CONSERVATION TEAM CONSULTATION APPLICATION RESPONSE

APPLICATION REF:	25/02814/FPH & 25/02815/LBC
CASE OFFICER:	VW
APPLICATION SITE:	Rye End Farm, Green Lane, Codicote, Hitchin, Hertfordshire SG4 8SU
DESCRIPTION OF WORKS:	Single storey front infill extension and single storey glazed extension linking main dwelling to existing entrance hall. Single storey front infill extension and single storey glazed extension linking main dwelling to existing entrance hall. Internal and external alterations.

The current proposal is shown below with a link from the lean-to entrance vestibule to the entrance door in the east elevation of the C17 east cross wing.

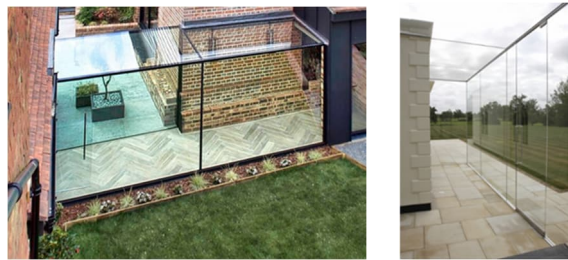
1. SL pointed out that the link from Main Farmhouse to East Stable would be too narrow for wheelchair access. MS/VW happy to consider a wider link and this may be possible by not constructing cavity walls (as suggested by MP).

2. Possibility of simplifying the link by removing the external door to courtyard and constructing a contemporary "glass box" structure on the existing external brickwork (see image types below).

3. MS expressed concerns regarding the lean-to infill addition between catslide roof and front door. MS considers i) the proposed loss of 4no. flush-panel door and brickwork to right-hand side together with ii) the new roof 'cut-out' to still express first floor window, objectionable. MS willing to consider a second "glass box" (subject to detail) which would sit below first floor window sill level but would clearly need to be higher than existing door lintels. As stated by SL, this would allow better circulation enabling the professional need for a confidential "at home" work room for Doctors/Owners consultations avoiding the current use of the room as the only passageway to the rest of the house. Post site meeting MS concerned that if a door is required in this glazed link that this will add to the framing required which would be unfortunate.

Plate 8: View looking E showing cross wing of farmhouse with porgetting on upper storey

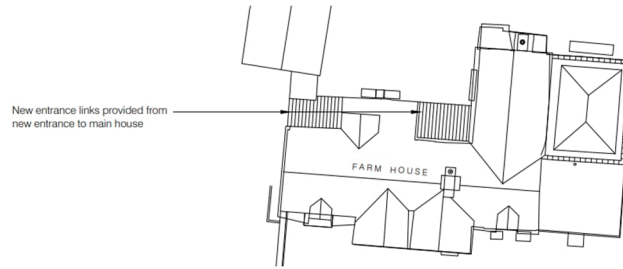
Plate 8 on page 14 of the Border Archaeology Heritage Statement shows clearly the door, window and brickwork that would be removed in the current proposal and which I am keen to see not happen.
